Generic Evaluation of Feedwater Transients and Small Break Loss-of-Coolant Accidents in Westinghouse-Designed Operating Plants

**Office of
Nuclear Reactor Regulation**

**U.S. Nuclear Regulatory
Commission**

**Bulletins and Orders Task Force
Office of Nuclear Reactor Regulation
U.S. Nuclear Regulatory Commission
Washington, D.C. 20555**

Auxiliary Feedwater System
Prairie Island
Figure 1

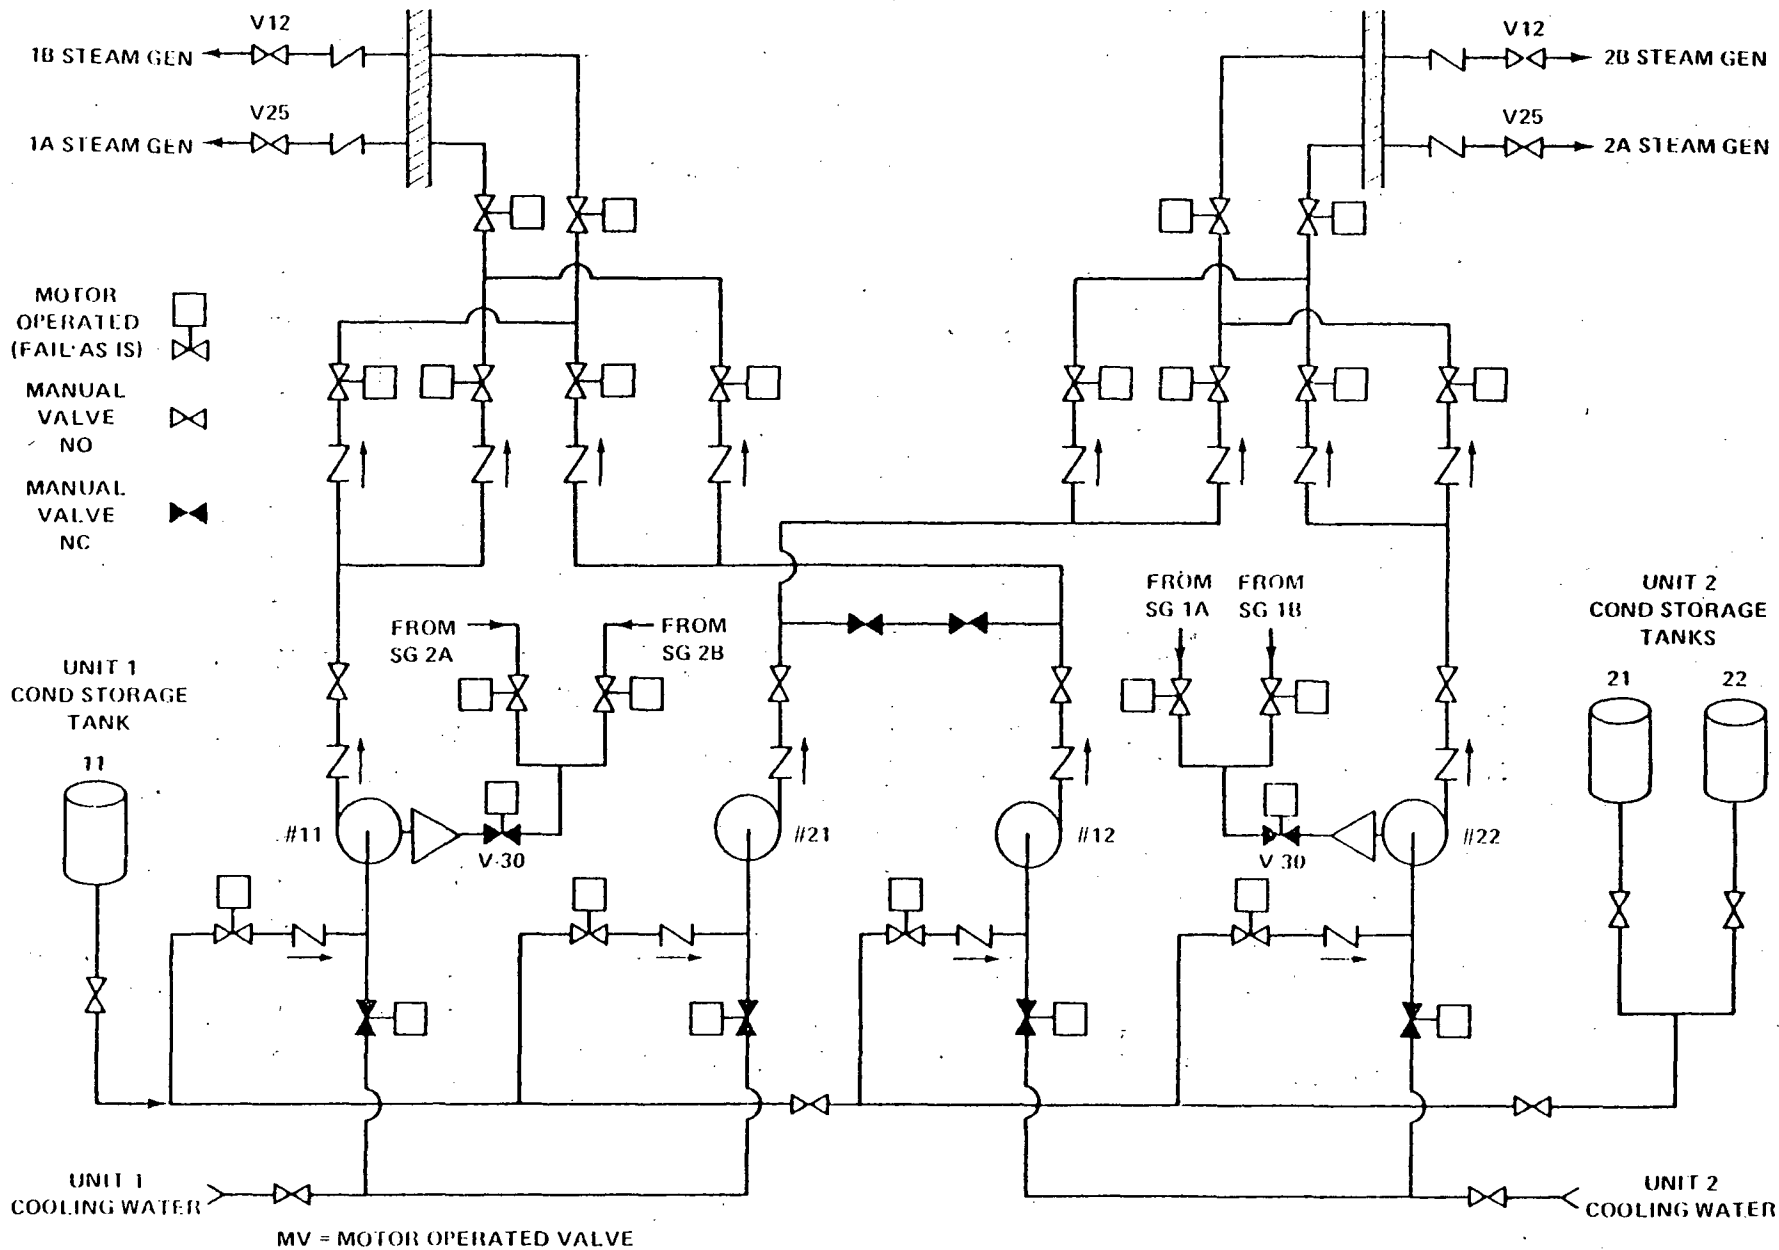
Long-term recommendations for improving the system are as follows:

Auxiliary Feedwater System
Pt. Beach 1 & 2
Figure 1

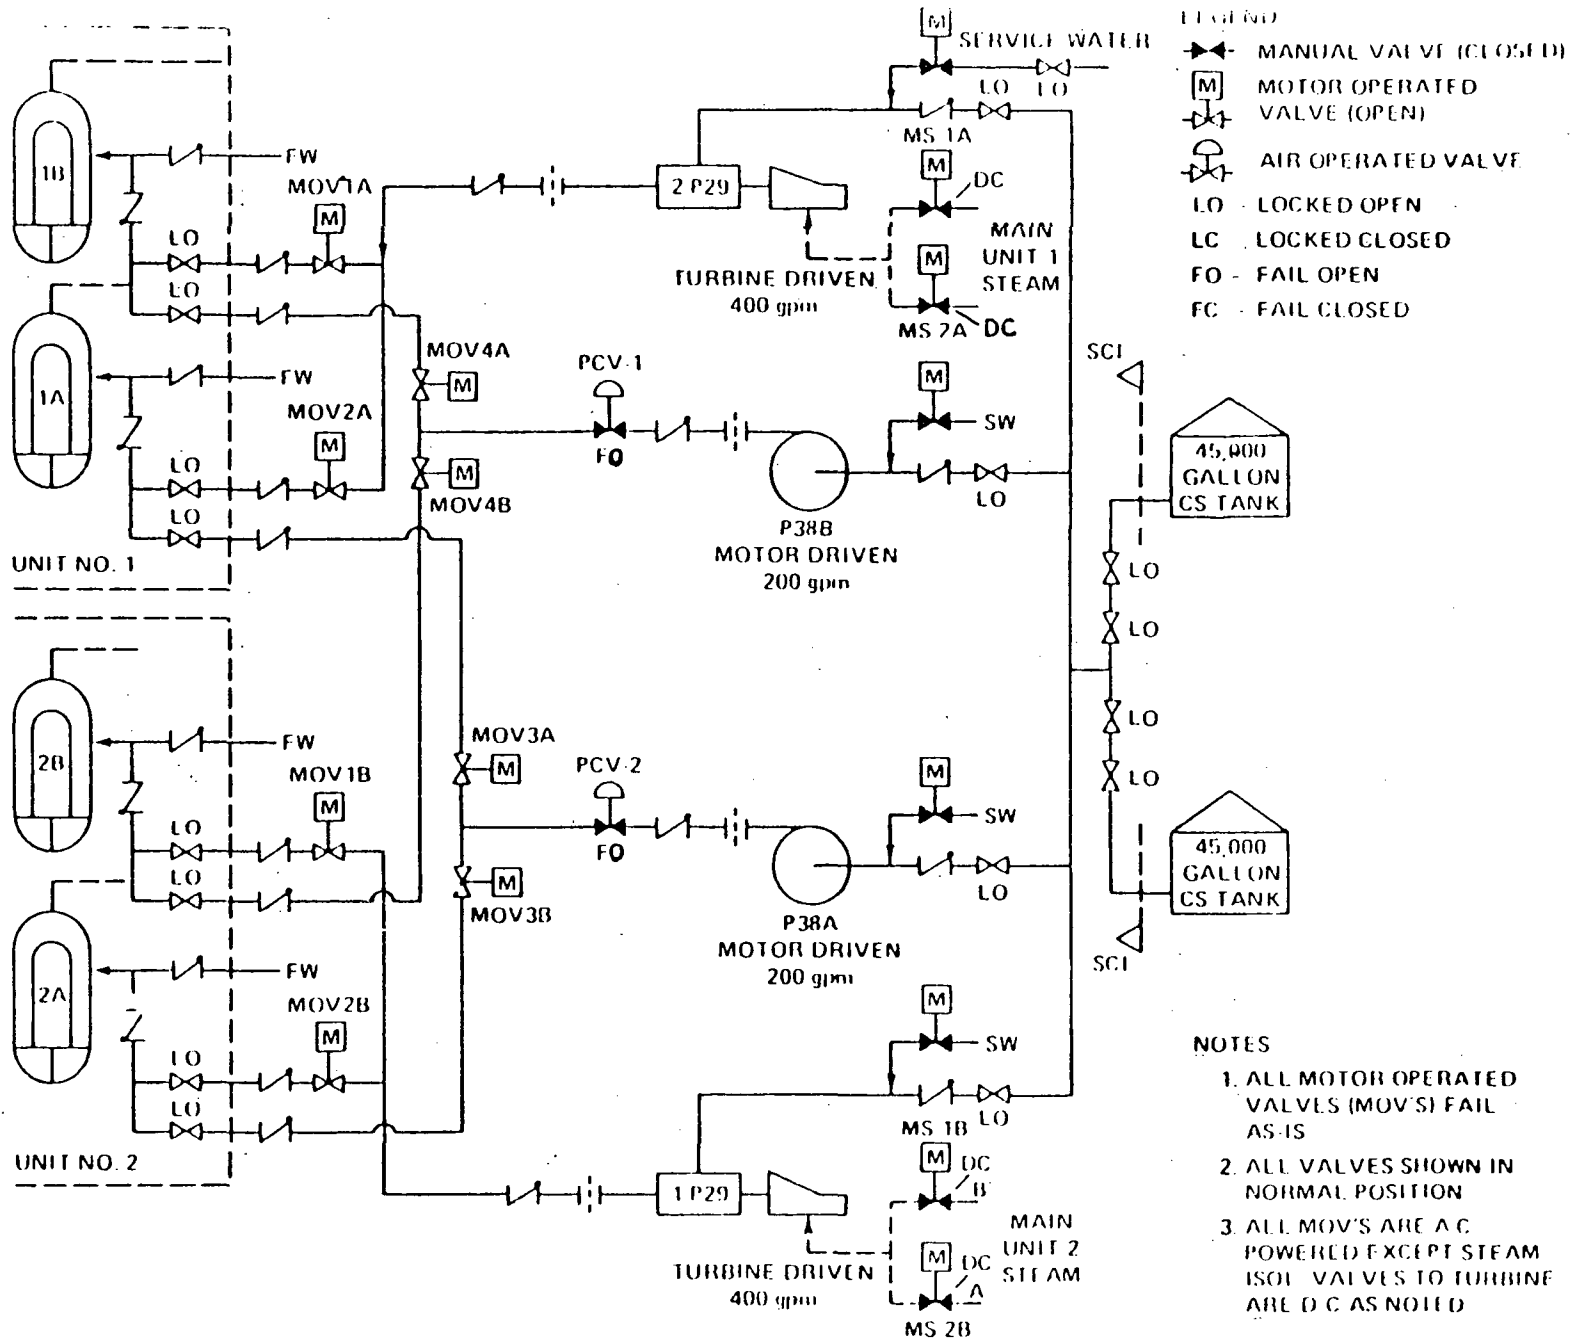
4. Recommendation - Licensees with plants which require local manual realignment of valves to conduct periodic tests on one AFW system train and which have only one remaining AFW train available for operation, should propose Technical Specifications to provide that a dedicated individual who is in communication with the control room be stationed at the manual valves. Upon instruction from the control room, this operator would re-align the valves in the AFW system train from the test mode to its operational alignment.

Auxiliary Feedwater System
Salem 1
Figure 1

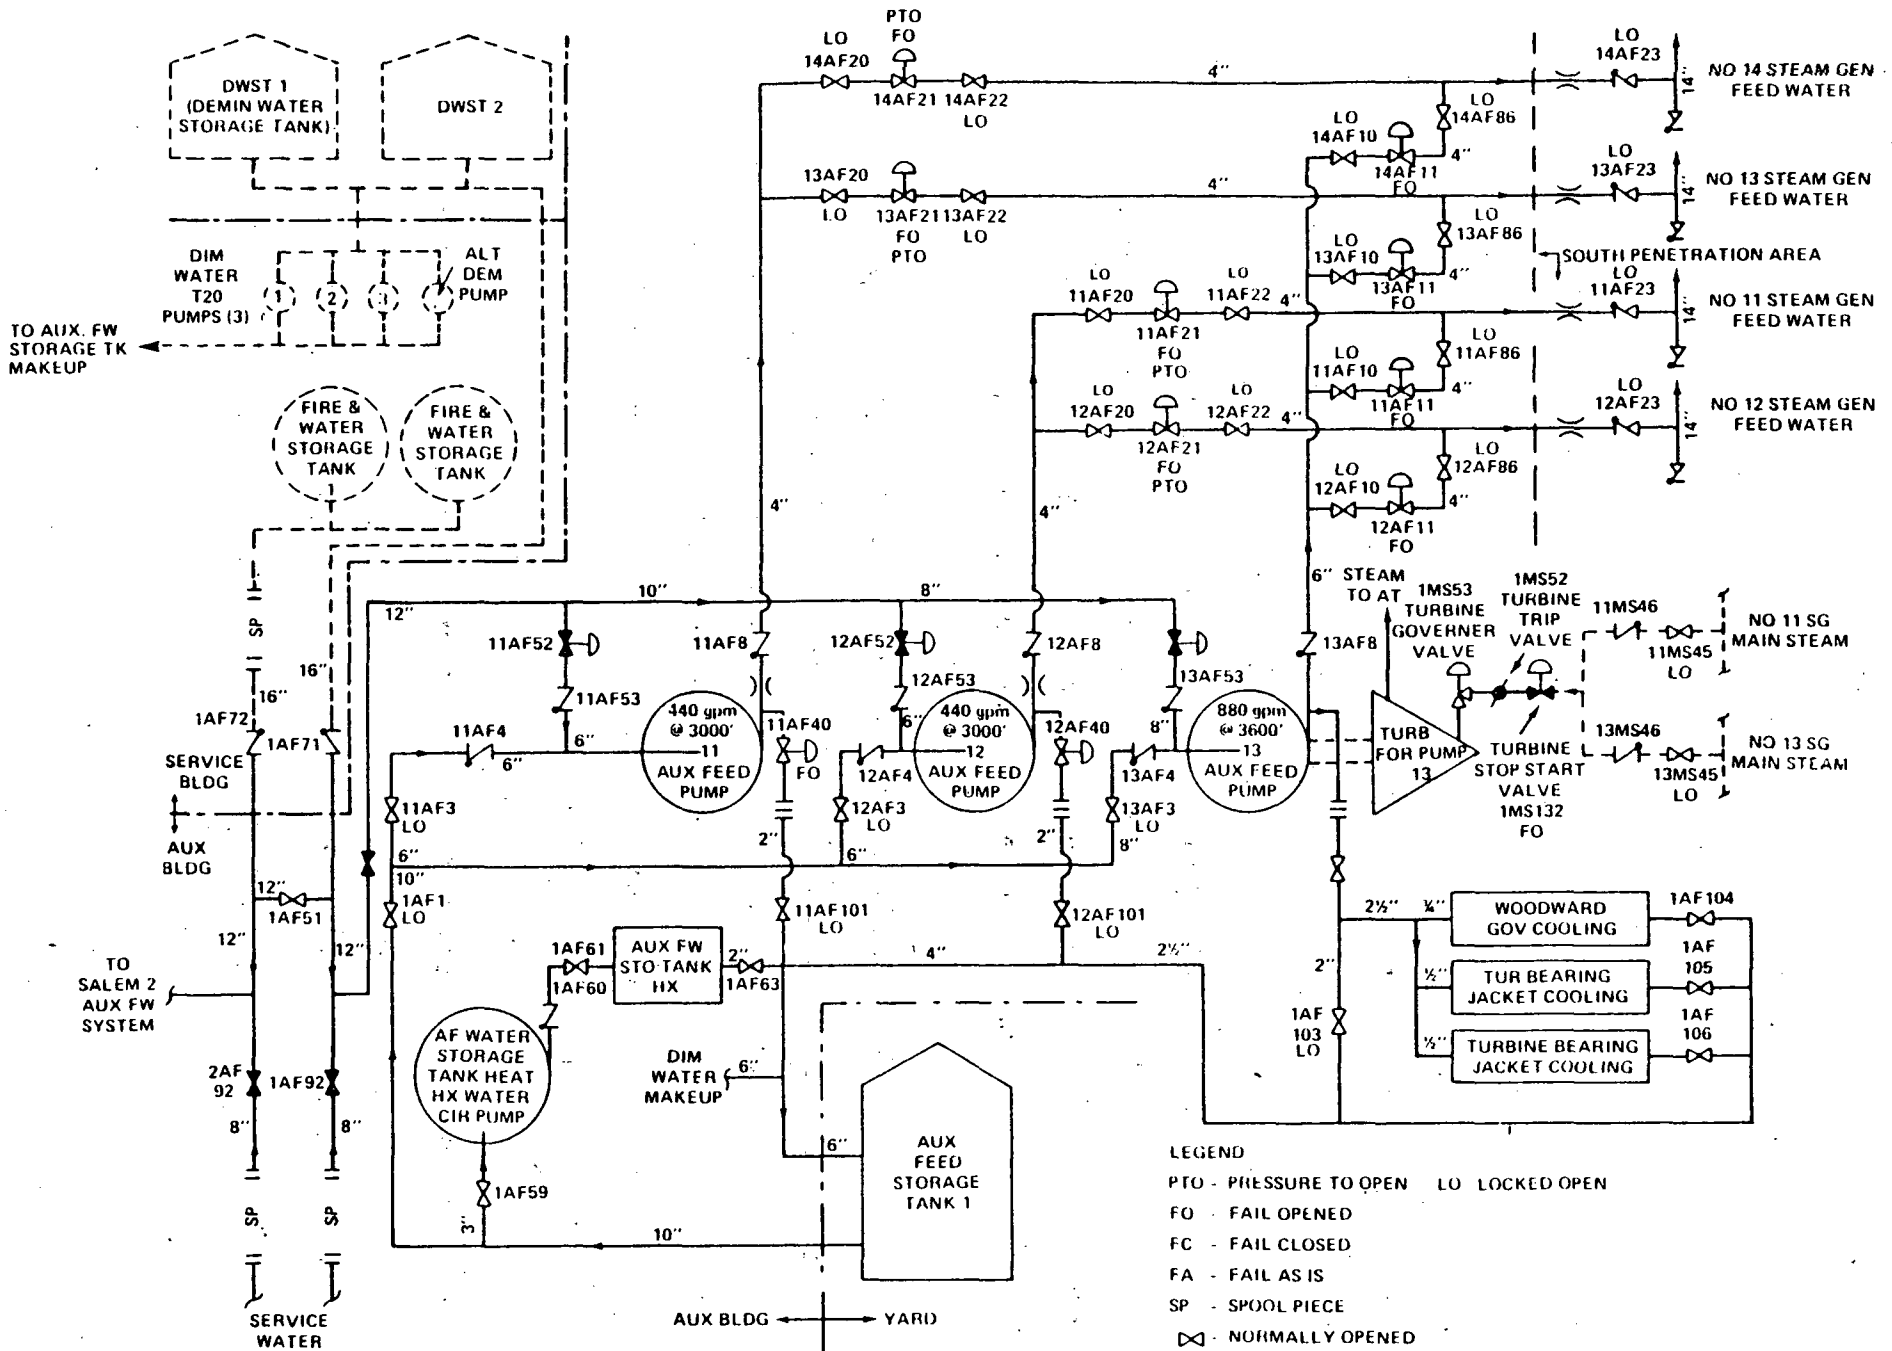
Long-term recommendations for improving the system are as follows:

1. Recommendation GL-2 - Licensees with plants in which all (primary and alternate) water supplies to the AFW systems pass through valves in a single flow path should install redundant parallel flow paths (piping and valves).

Auxiliary Feedwater System
San Onofre 1
Figure 1

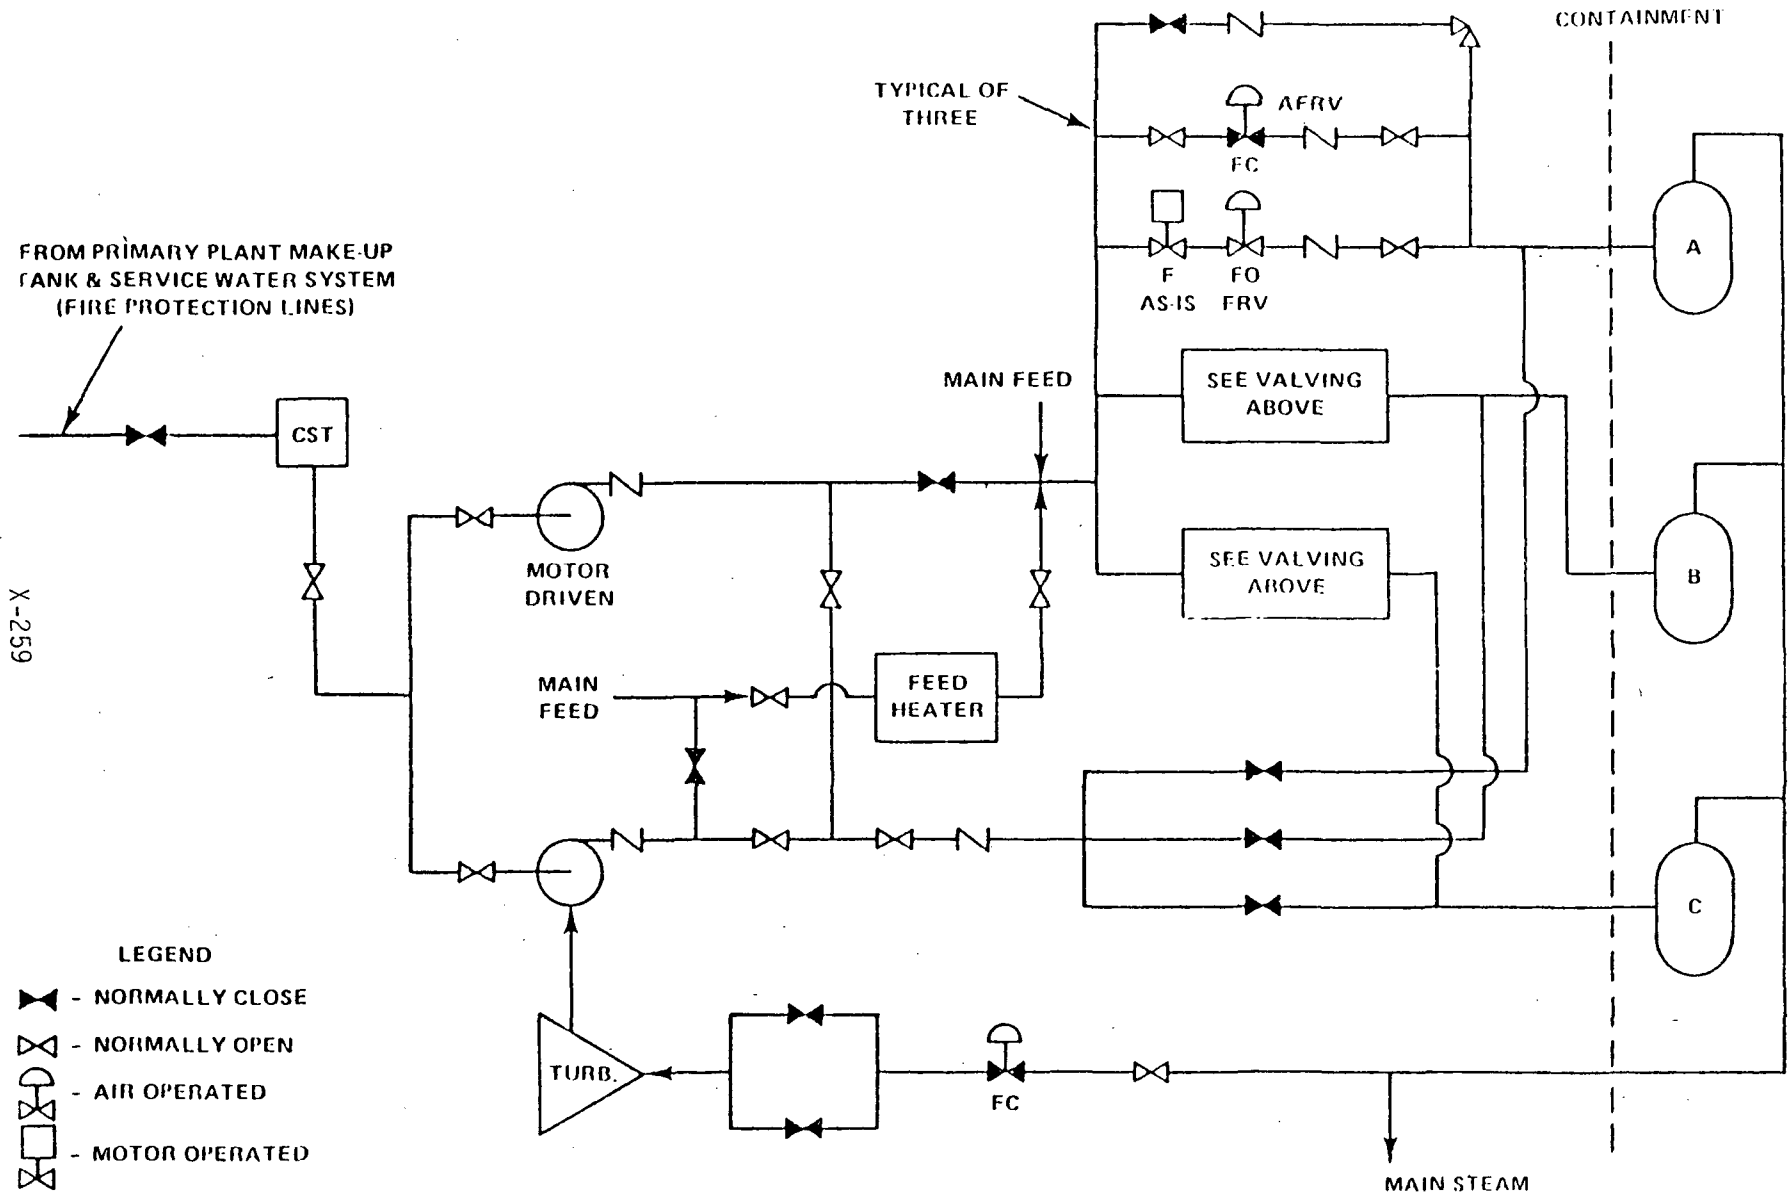
5. Recommendation - The licensee should evaluate the following concerns:
- a) A break in the main feed or main steamline outside containment or a break in the steamline to the turbine driven AFW pump may result in environmental conditions for which the main feed and AFW system components are not qualified.
 - b) The San Onofre Unit 1 AFW system design does not meet the high energy line break criteria in SRP 10.4.9 and Branch Technical Position 10-1; namely, that the AFW system should maintain the capability to supply the required AFW flow to the steam generator(s) assuming a pipe break anywhere in the AFW pump discharge lines concurrent with a single active failure.

The licensee should evaluate the postulated pipe breaks stated above and (1) determine any AFW and main feedwater system design changes including environmental qualification, or procedures necessary to detect and isolate the break and direct the required feedwater flow to the steam generator(s) before they boil dry or (2) describe how the plant can be brought to a safe shutdown condition by use of other systems which would be available following such postulated events.
